CERTIFICATE OF APPROPRIATENESS

Property: 734 Arlington Street, Lot 21, Block 257, Houston Heights Subdivision. The property includes a historic 1,198 square foot residence situated on a 6,600 square foot (50' x 132') interior lot.

Proposal: Alteration – *Revision*

The applicant now proposes the following revisions.

NORTH SIDE ELEVATION

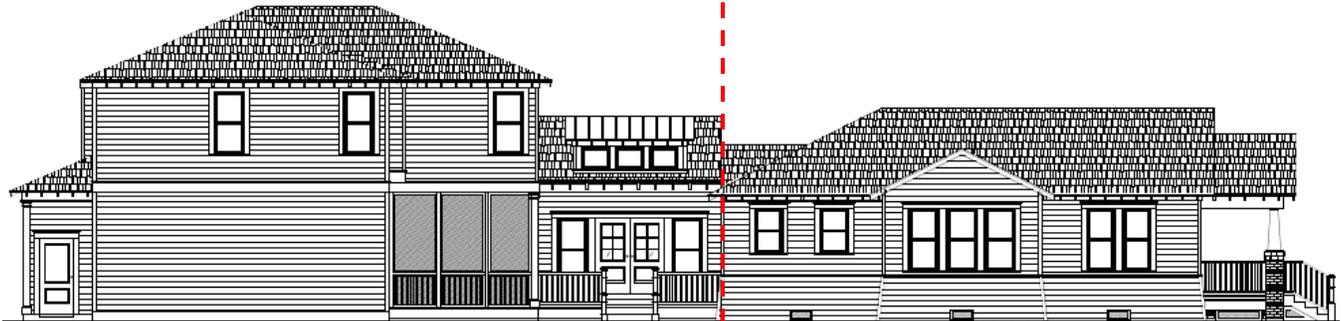
Revise proposed side porch to feature 16' wide steps. These steps will be inset from the north side wall of the existing residence.

SOUTH SIDE ELEVATION

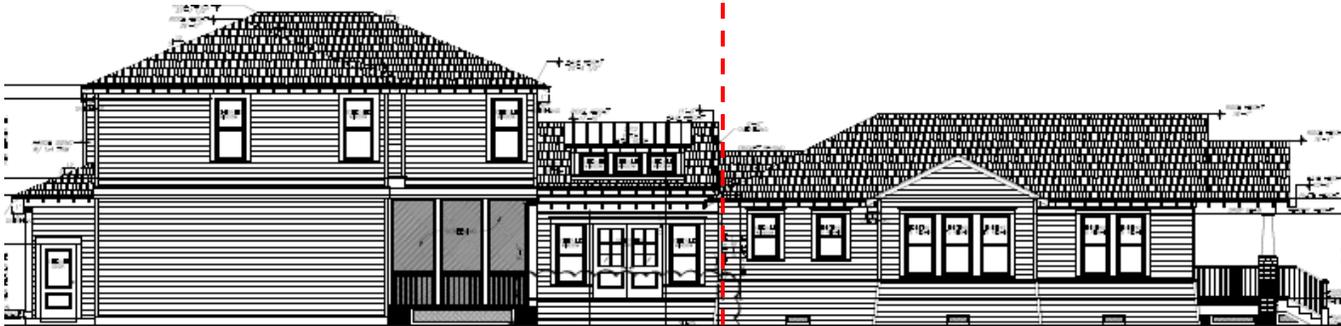
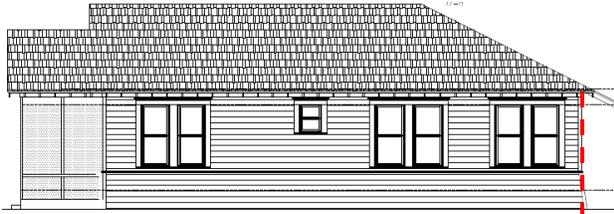
- Replace an existing 2' wide by 2' 6" tall non-original metal window on the south elevation of the existing structure with a matching wood window.
- Revise the fenestration on the south elevation of the addition.
- Revise the steps for the approved side porch along the north elevation.

Change a pair of approved 6' tall 1-over-1 windows flanking an approved chimney on the south side of the addition to 4' tall windows. Move an approved second story window at the proposed stairwell of the addition to be situated between the first and second floors.

PROPOSED FIRST FLOOR PLAN

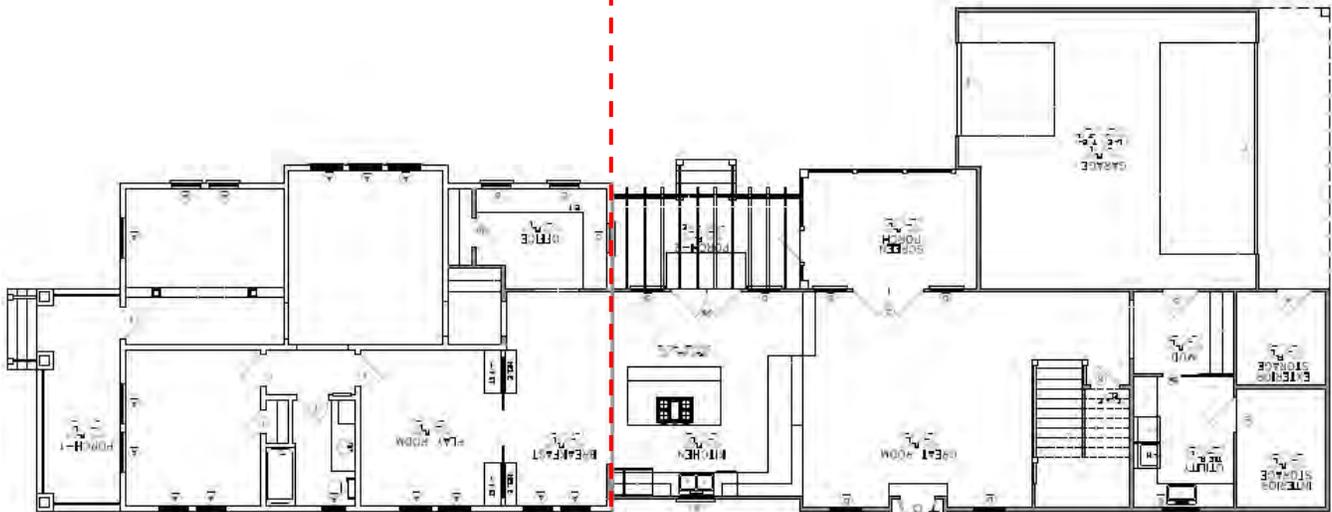
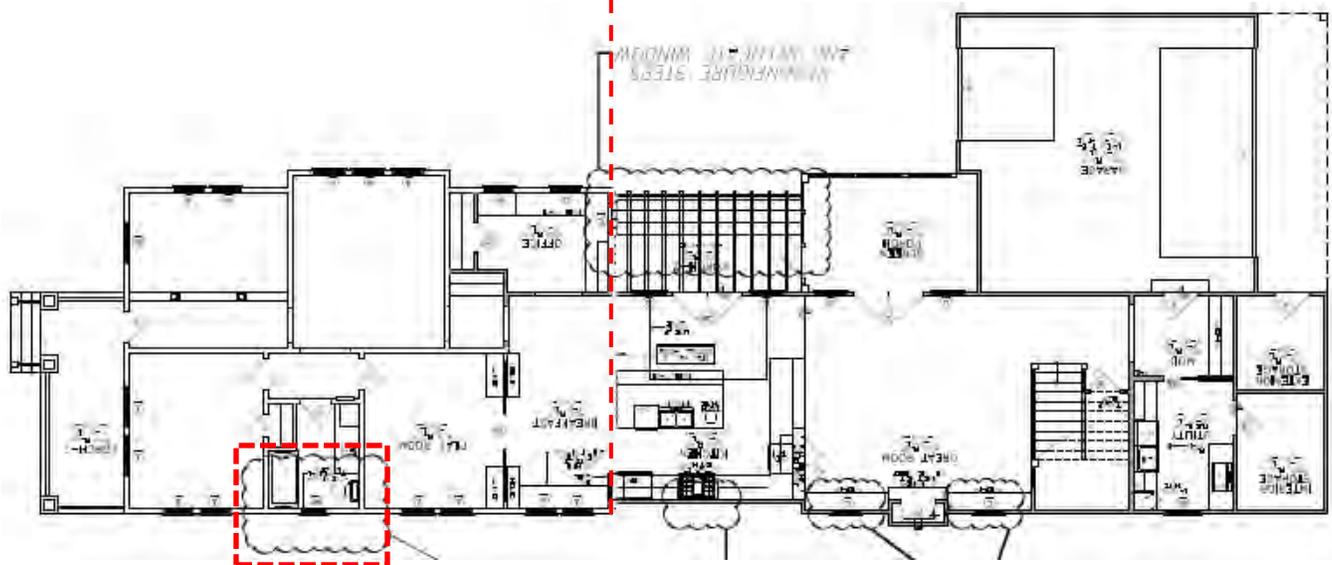
Proposed Revision: An existing non-original metal framed 2' wide by 2' 6" tall 1-over-1 window will be replaced with a matching wood window.
